PRODUCT UPDATE

CG03129 - 3FT (0.9M) 18 AWG Universal Power Cord (NEMA 5-15P TO IEC320C13)

What Has Changed?

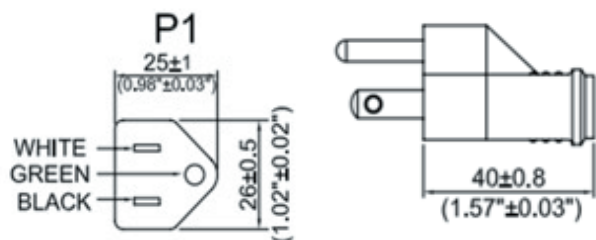
1. The **NEMA 5-15P connector** now features a minor visual update, with **double lines around the pins**.
2. The **NEMA 5-15P connector dimensions** have been adjusted from **40mm ± 0.8 mm x 26mm ± 0.5 mm x 25mm ± 1 mm (LxWxH)** to **38mm ± 1 mm x 21mm ± 0.4 mm x 23.6mm ± 0.4 mm (LxWxH)**.
3. The **temperature rating** has been upgraded from **75°C to 105°C** to comply with the latest **UL and CUL standards**.
